Regional Development Committee

RD22.1	RA17/1000 - Anson Street St Georges Basin - Lot 1 & 6 DP 1082382 - Concept Development Application	
	Attachment 1 Section 4.15 Planning Assessment Report.....	2
	Attachment 2 Concept Masterplan Plans and Yield Analysis.....	84
RD22.2	SF10633 - 169 Hockeys Lane (Lot 1 DP 1281124), 121 Taylors Lane (Lot 2 DP 1281124) - Lot 5 DP 1256748 Taylors Lane - Cambewarra - Staged residential subdivision to create 126 Torrens Title allotments	
	Attachment 1 Council Section 4.15 Planning Assessment Report.....	97
	Attachment 2 Draft Notice of Determination - Development Consent	146

COUNCIL ASSESSMENT REPORT

Panel Reference	PPS-2017STH009
DA Number	RA17/1000
LGA	Shoalhaven City Council
Proposed Development	Concept masterplan for a mixed-use development (comprising of residential flat buildings, commercial premises and shop top housing) and associated minor boundary adjustment subdivision
Street Address	Anson Street, St Georges Basin
Applicant/Owner	Eastern Grey Developments Pty Ltd / David DeBattista
Date of DA lodgement	30 March 2017
Total number of Submissions Number of Unique Objections	Council received 250 submissions objecting to DA in 2017 and 83 sub

Figure 27. Perspective View plan looking east along Anson Street [M11D]

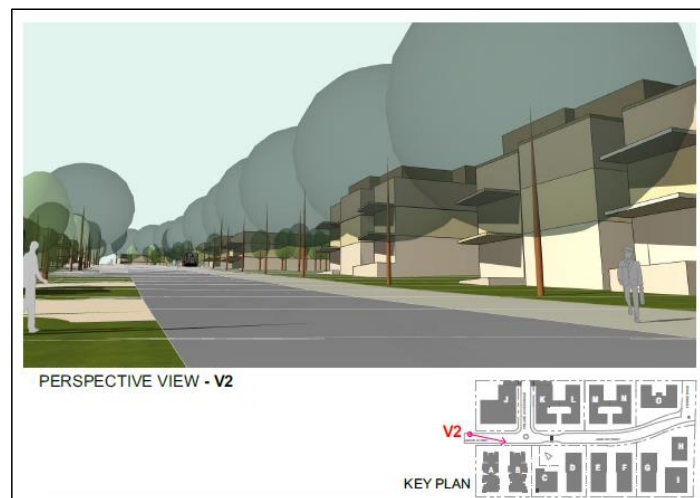
Each of these individual elements of this critical element are addressed throughout this report. Building heights is of key concern with the development, not only as it is not considered a future 'Stage 2' DA would be capable of complying with the Concept DA, but due to the bulk and scale this type of development will present to Anson Street and the impacts this will have on the character of the neighbourhood. **Figure 27** shows the appearance of the proposed buildings (building envelopes and potential development) in the streetscape with **Figure 28** depicting the current character of the neighbourhood at this location. The dominance of the development as a whole will cause detrimental impacts to the streetscape and from an urban design perspective is not consistent with the vision intended for the St Georges Basin area as outlined in SDCP 2014.

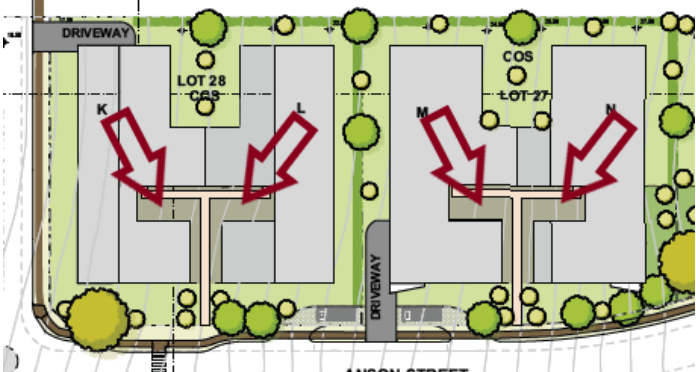
Principle 7: Safety	<p>The proposed concept DA contains high-level information that makes the assessment of 'safety' difficult to ascertain. This Principle states: <i>Good design optimises safety and security within the development and the public domain. It provides for quality public and private spaces that are clearly defined and fit for the intended purpose. Opportunities to maximise passive surveillance of public and communal areas promote safety.</i></p> <p>The position of driveways and entry points appear to provide opportunity for concealment particularly the corner access arrangements proposed for Buildings K, L, M & N as shown at Figure 34.</p>

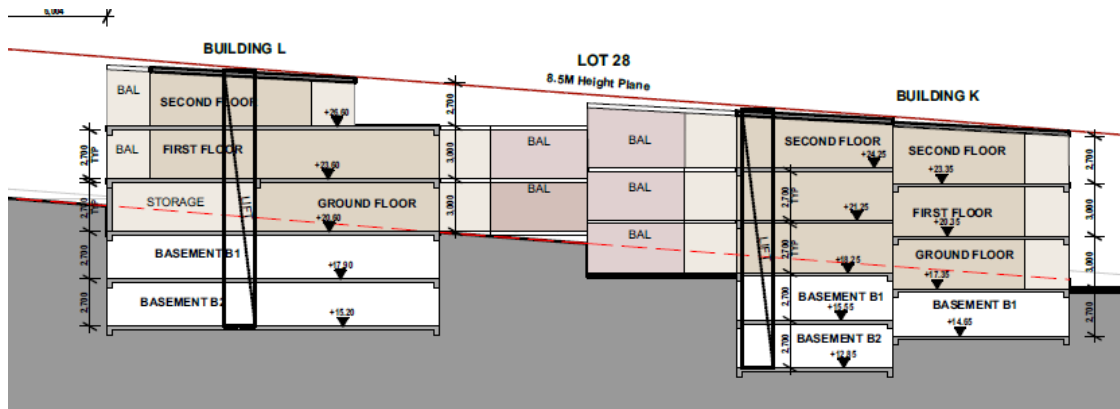
The Sections and Elevations Plan [M03D] shows a typical floor-to-floor height of 3m Buildings C, D, E, F, G, H, I, K, L, M, N and O. An excerpt of Buildings L and K is shown below at **Figure 37**, noting the 3m floor to floor heights shown.

It is noted that a survey of the land which accurately reflects existing ground levels of the site has not been submitted so that the Height Plane [M09D] can be verified and the overall maximum height of the building envelopes can be accurately assessed.

The Apartment Design Guide (ADG) Design Criteria 2C-1 1 and ADG Figure 4C.5 specifies a floor-to-floor height of 3.1m is required to achieve the required floor-to-ceiling height of 2.7m (ADG 4C-1 1). Floor-to-floor heights of 3m are insufficient to fit the required services bulkhead for a residential flat building, and reduced floor to ceiling height results in reduced and unacceptable amenity for future apartments.

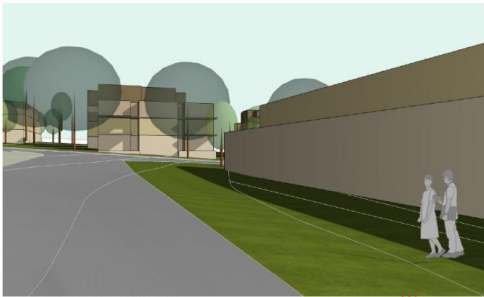
3C-1 Public Domain Interface <i>Transition between private and public domain is achieved without compromising safety and security.</i>	<p>The proposed setbacks to Anson Street of all buildings and the design and layout of buildings do not promote suitable transitions between private and public domain spaces without compromising safety and security. The setback distances, building envelope designs and landscaped areas proposed would provide areas of concealment and discourage pedestrian connectivity to the street.</p>	No
3C-2 Public Domain Interface <i>Amenity of the public domain is retained and enhanced.</i>	<p>The bulk and scale of the proposed buildings are contrary to the existing and desired future character of St Georges Basin. The proposed buildings will dominate the street and public domain (refer Figure 38</p>	No

<p>with Buildings C and B in the distance and J on the right). The amenity of the public domain will not be retained or enhanced by the proposed development.</p>  <p>PERSPECTIVE VIEW - V4</p>  <p>KEY PLAN</p> <p>Figure 38. Perspective view of proposed built form as viewed down the Village Access Road (now known as Crowea Rd)</p>	
<p>3D-1 Communal and Public Open Space</p> <p><i>An adequate area of communal open space is provided to enhance residential amenity and to provide opportunities for landscaping.</i></p> <p><i>Communal open space has a minimum area equal to 25% of the site (see figure 3D.3)</i></p> <p><i>Developments achieve a minimum of 50% direct sunlight to the principal usable part of the communal open space for a minimum of 2 hours between 9 am and 3 pm on 21 June (mid-winter)</i></p>	No design information provided at Concept DA stage.	N/A
<p>3D-2 Communal and Public Open Space</p> <p><i>Communal open space is designed to allow for a range of activities, respond to site conditions and be attractive and inviting.</i></p>	No design information provided at Concept DA stage.	N/A

Figure 40. Building Envelope Plan of Buildings G, H and I [M02, Rev D] identifying setbacks between buildings that have not been adequately addressed.

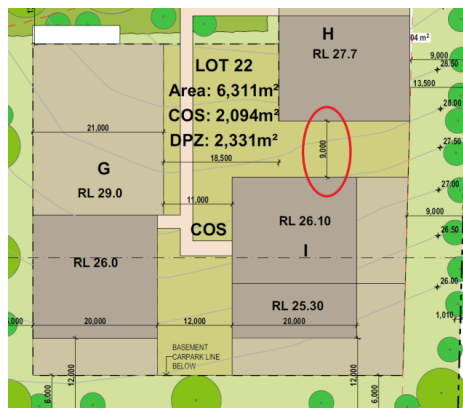
<p>3F-2 Visual Privacy</p> <p><i>Site and building design elements increase privacy without compromising access to light and air and balance outlook and views from habitable rooms and private open space.</i></p>	<p>This level of detail would be assessed with any subsequent 'Stage 2' DA.</p>	<p>N/A</p>
<p>3G-1 Pedestrian Access and Entries</p> <p><i>Building entries and pedestrian access connects to and addresses the public domain.</i></p>	<p>Pedestrian entry points for buildings are in some instances (e.g. Building I) some 56m from the street frontage at Anson Street. This design does not connect to or address the public domain. Other instances such as Buildings K&L and M&N, the pedestrian entrances are tucked behind the courtyard design of the buildings, creating areas of potential concealment and a maze like navigation to reach the front entry points of the buildings.</p>	<p>No</p>

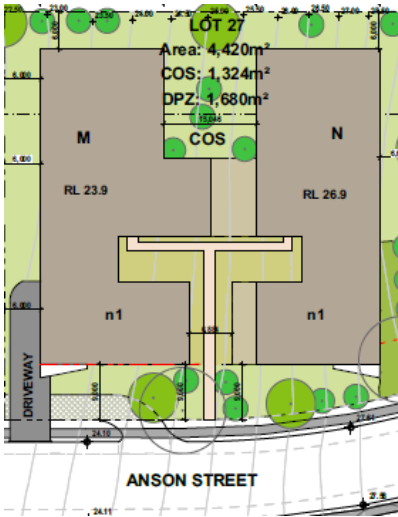
4F-2 Common Circulation and Spaces <i>Common circulation spaces promote safety and provide for social interaction between residents.</i>	N/A - Concept DA. This is design details for a future building.	N/A
4G-1 Storage <i>Adequate, well designed storage is provided in each apartments.</i>	N/A - Concept DA. This is design details for a future building.	N/A
4G-2 Storage <i>Additional storage is conveniently located, accessible and nominated for individual apartments.</i>	N/A - Concept DA. This is design details for a future building.	N/A
4H-1 Acoustic Privacy <i>Noise transfer is minimized through the siting of buildings and building layout.</i>	The design of Buildings M and N, with the central courtyard design is of concern of noise reverberation and transmission. While the 'proof-of-concept' plans have been submitted, these are not able to be reconciled with the development as proposed under the current revision of plans, and thus the amenity	No

<p>impacts of the proposed building envelopes not adequately assessed.</p>  <p>Figure 41. Building Envelope Plan of Buildings M And N [M02, Rev D] identifying courtyard portion of the buildings likely to cause acoustic impacts</p>	
<p>4H-2 Acoustic Privacy</p> <p>Noise impacts are mitigated within apartments through layouts and acoustic treatments.</p>	<p>N/A - Concept DA. This is design details for a future building. IN any event a condition could be imposed with regard to benchmarks to demonstrate vertical and horizontal noise transition can be adequately mitigated within buildings.</p>	N/A
<p>4K-1 Apartment Mix</p> <p>A range of apartment types and sizes is provided to cater for different household types now and into the future.</p>	<p>The overall proposed development consists of the following units mix across the proposed 13 new buildings:</p> <ul style="list-style-type: none"> approximately 14 x 1 bedroom apartments; approximately 92 x 2 bedroom apartments; approximately 131 x 3 bedroom apartments; and an approximate total of 237 apartments. <p>While the number of apartments and mix shown in the Masterplan Yield table [D] are unable to be verified, the proposed development does not meet the needs of the community with regard to the size and uniformity of housing typology.</p> <p>The proposed development does not provide for the needs of the much higher than average proportion of people with a disability with regard to, for example, with accessibility of the site, adaptable housing and design.</p> <p>The assessment provided by Council's Social Planning Expert, Judith Stubbs, states:</p> <p><i>"The first issue related to mismatch is that of bedroom number to meet projected need. As noted, there will be</i></p>	No.

Shadow Analysis - 9AM

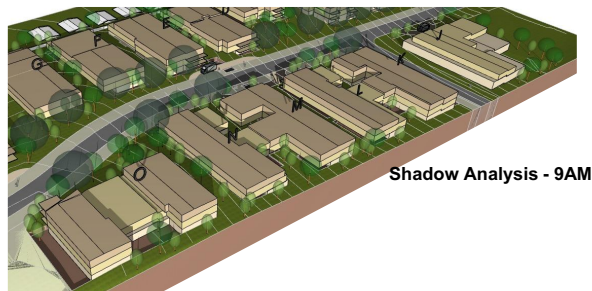
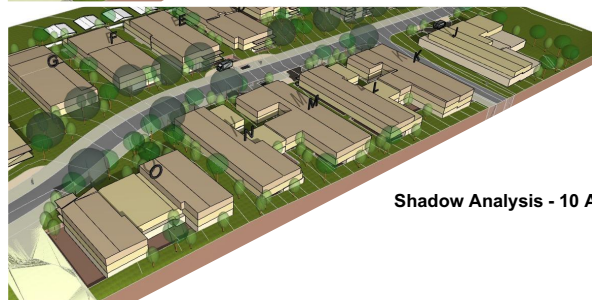
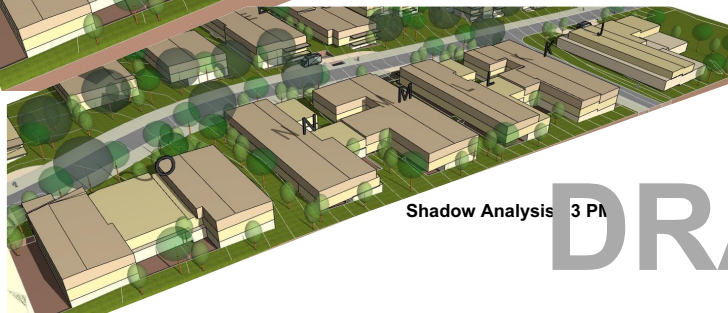
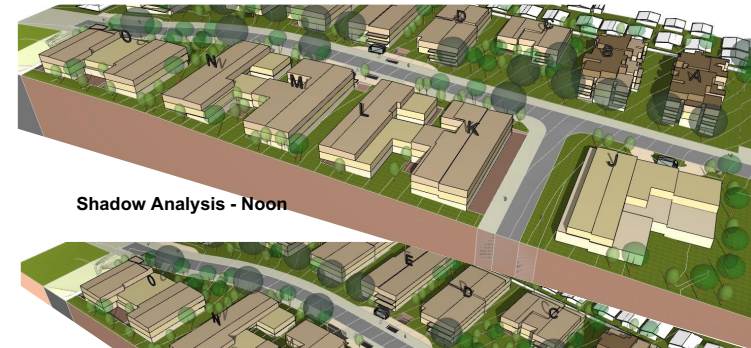
*"The Shadow Analysis [M04D and M05D] technique (e.g. **Figure 29**) is unclear and does not assist in the assessment of building amenity. 'View from the sun' diagrams should be provided at half hour intervals.*

Shadow Diagram - 21 June - 9 AM
1:750

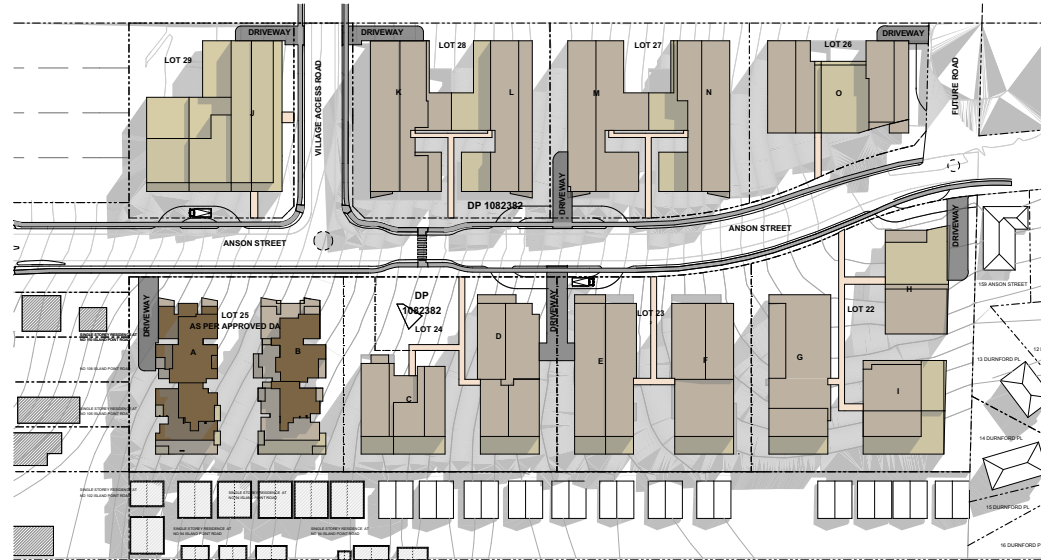
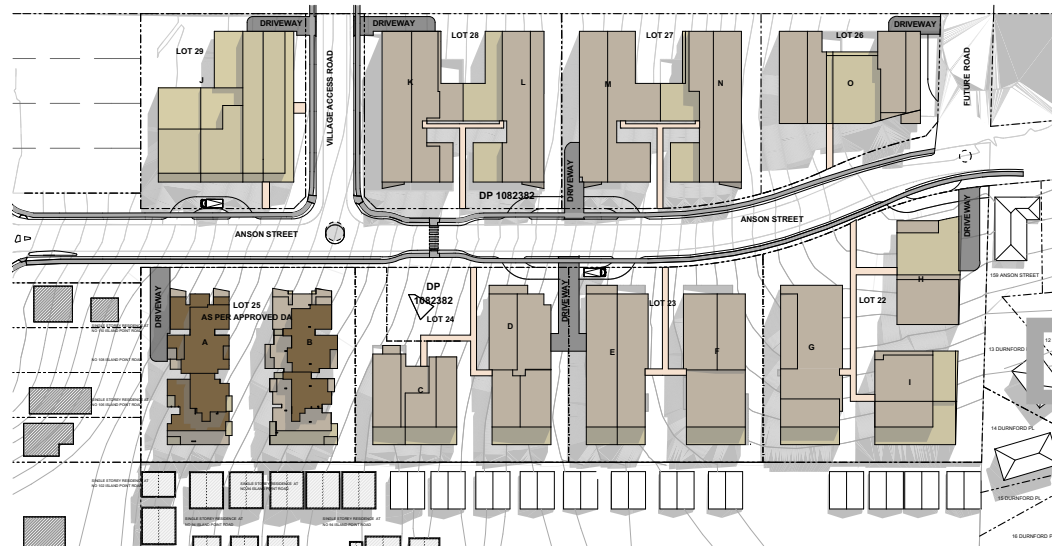
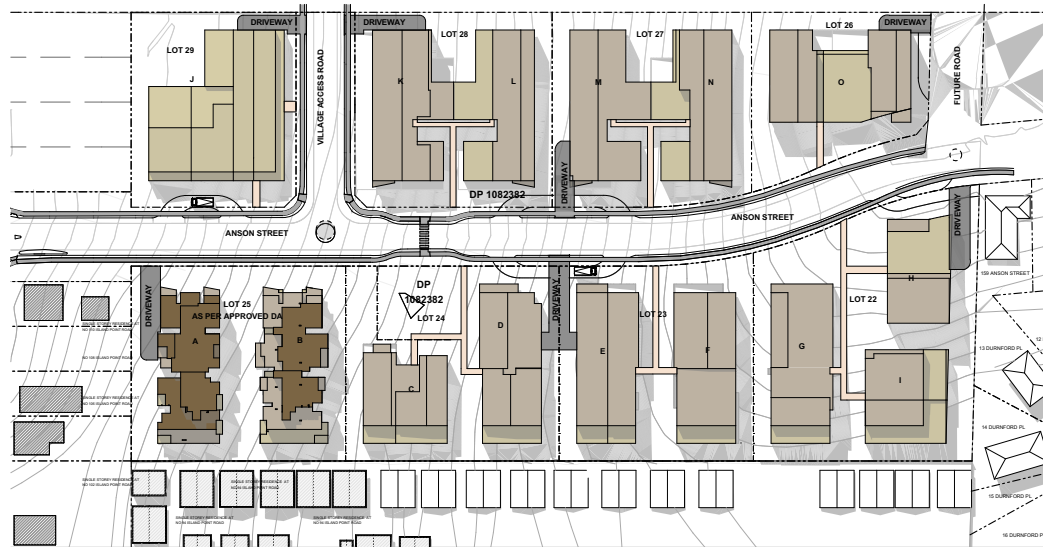
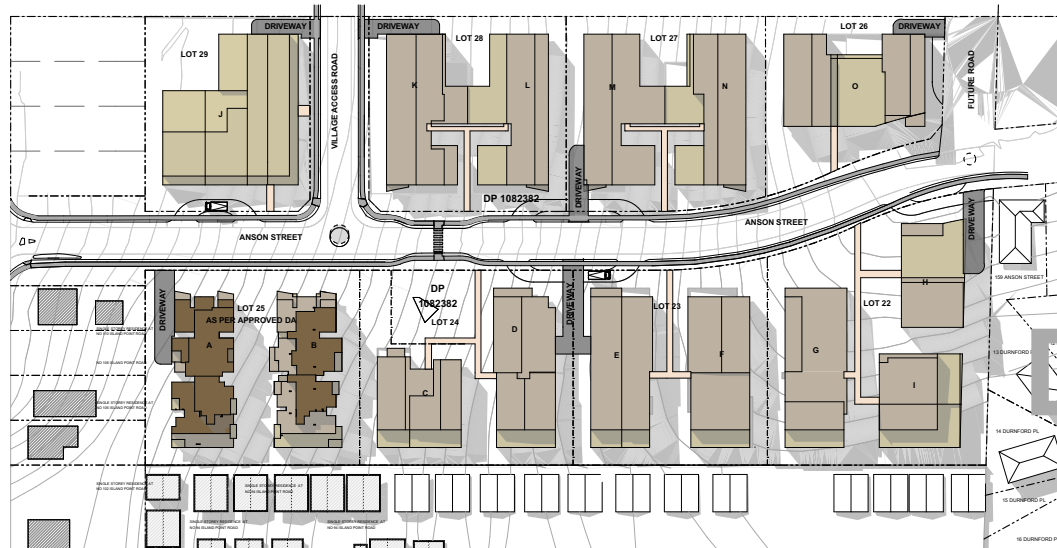
The public domain and neighbouring development should be included in the diagrams, particularly the site to the south. (m) The Shadow Diagrams [M06D to M09D] show that proposed Buildings J, K, L, M, N and O overshadow the northern footpath of Anson Street (SDCP2014 N23 5.2 A5.1). This is not consistent with minimising shadowing of publicly accessible open spaces (SDCP2014 N23 5.2 A4.1)"
